Marine
Management
Organisation

MMO Reference: DCO/2022/00008

Planning Act 2008, National Grid Electricity Transmission, Proposed Sea Link Project

Deadline 4 Submission

Figure 1: Percentage gravel sand and silt/clay for 48 samples from proposed dredge area

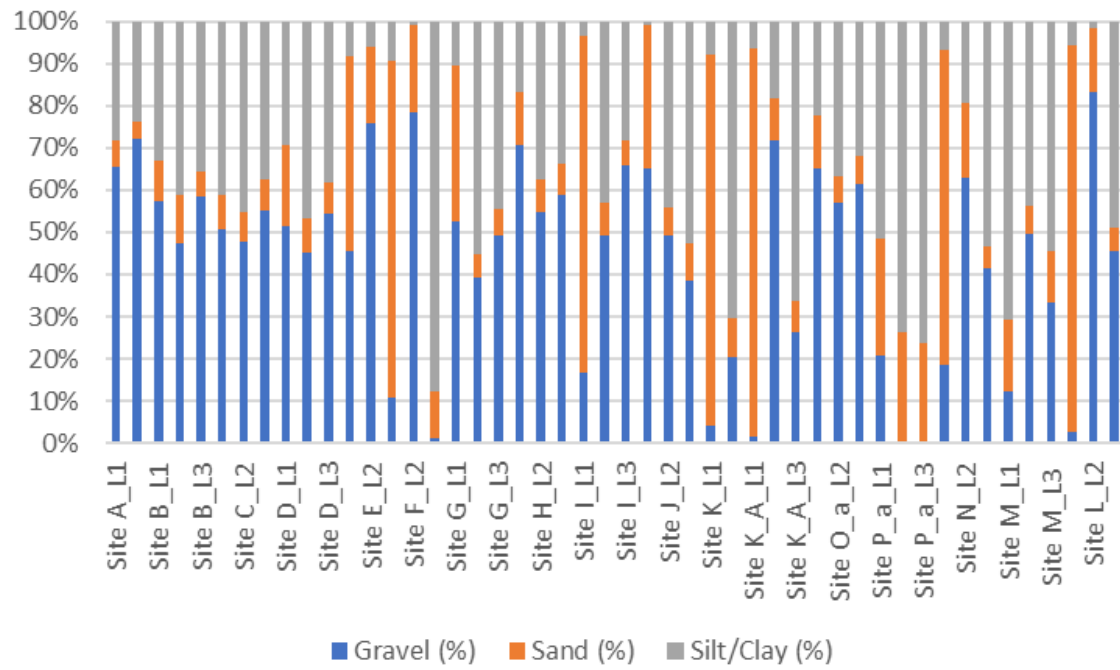
The sample results provided did not include the location coordinates in the correct format, therefore it is not possible to determine if they are representative of the cable corridor. Whilst assessment of results indicates that the risk of the release of contaminants from the activity is likely to be low, this may not address issues regarding plume effects and increased turbidity from the use of some trenchless techniques that may need to be considered. This would depend on the volumes, the techniques to be used and any potentially sensitive receptors present. Chapter 1 confirmed that a sediment transport model has been developed to evaluate the dispersion of sediment resulting from various cable burial techniques, as well as to determine the extent of sediment deposition on the seabed (refer to Application Document 6.3.4.1.A Suspended Sediment Modelling). The MMO notes that the potential impacts of increased turbidity and elevated suspended sediment concentrations are assessed in Section 1.7.

Chapter 1 Section 1.7.82. states that *“ As part of the MMT (2022) survey, 32 grab sample sites were selected for analyses of concentrations of metals, organics, PAHs, and THC”*. The Applicant has provided the 2022 and additional 2024 survey reports but does not appear to have submitted the 2022 sample results (which are presented in the survey report) in the standard MMO results template as has been requested. The MMO requests that the Applicant submit the sample data in the correct format for review, and if possible, the Certificates of Analysis. If the Applicant can confirm that only the 2024 results provided are the ones to be used for characterisation of the area, i.e. are

Figure 2: Analysis of Arsenic in 48 samples indicate some samples above AL1 but well below the AL2

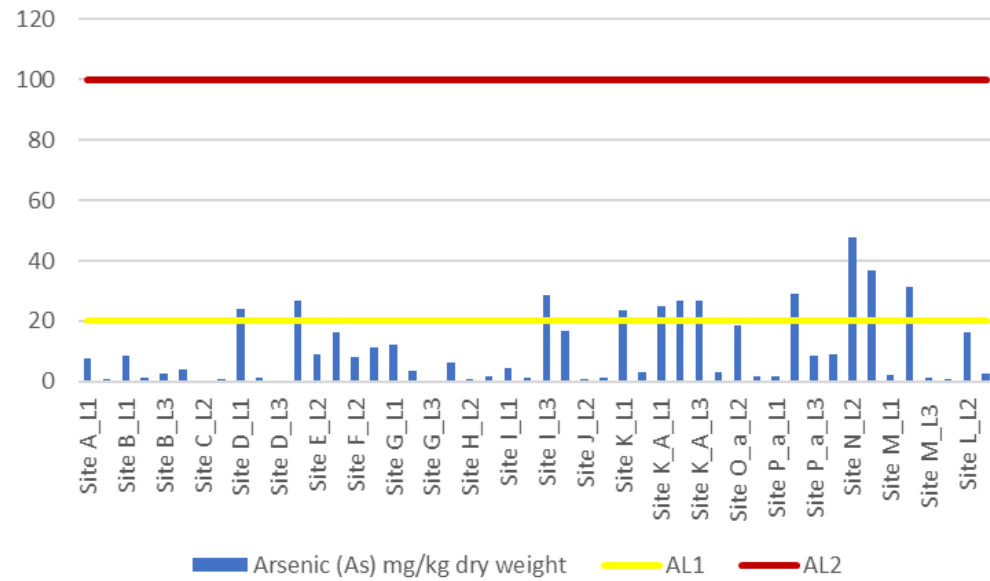
<p>1PE3</p>	<p>Suspended sediments and contamination</p> <p>Do any of the areas of sediment bound contamination along the marine cable route identified as exceeding CEFAS Action Level 1 in section 1.7 of [REP1-051] require special working arrangements to minimise adverse effects (for example, adjacent to Goodwin Sands or within Pegwell Bay?).</p>	<p>The MMO made preliminary comments on suspended sediments and contamination at Deadline 3. Those comments were based on a preliminary review and on the assumption that they are representative of the full cable route and therefore at the time had not been plotted to check their coverage. This was due to time constraints in responding to ExQ1. The MMO stated it was therefore still undergoing review of the sample results provided and may provide further comments at Deadline 4.</p> <p>Following further review, it has been established that the MMO Results template MAR02534 with samples Sites A to K is not filled in appropriately. The Applicant should provide a completed Template to the MMO. The 'Application info' tab is missing dredge area tonnages and application information that includes sampling dates, and the applicant etc. is empty. As such, it is not possible to determine if these results are timely with regard to supporting the application. The Dredge area tonnages box is also empty; this requires the estimated maximum tonnage in wet tonnes anticipated as a result of the works. In the sample numbers and locations information tab, the data is requested in decimal degrees, whereas the Applicant has presented eastings and northings, this is insufficient to determine whether the samples are fully representative of the proposed cable area. The MMO requests that the Applicant provide completed MMO results templates by addressing these issues.</p> <p>The MMO notes that the proposed dredge sediment comprises predominantly gravels (mean 44%) with sand (mean 22%) and silt clays (mean 34%) (see Annex 1, Figure 1).</p> <p>For trace heavy metals, most analysis indicated levels below their respective Action Level 1 (AL1), with the exception of arsenic, chromium, and nickel. Levels of arsenic were mostly below AL1, for the eleven samples above AL1 they were well below the upper Action Level 2 (AL2) (see Annex 2, Figure 2). For chromium and nickel only two samples of the 48 (different samples) marginally exceeded their relevant AL1. Levels of arsenic can be in excess of AL1 depending on the geology of the area, therefore this is not of concern in this area.</p> <p>Levels of mercury were shown to be low either around or below the limit of detection (LOD). Similarly, levels of polycyclic aromatic hydrocarbons were mostly below the LOD and those not, were only just detectable.</p>

The levels of contaminants analysed in the 48 samples indicate that the risk of the release of contaminants from the activity is expected to be low.
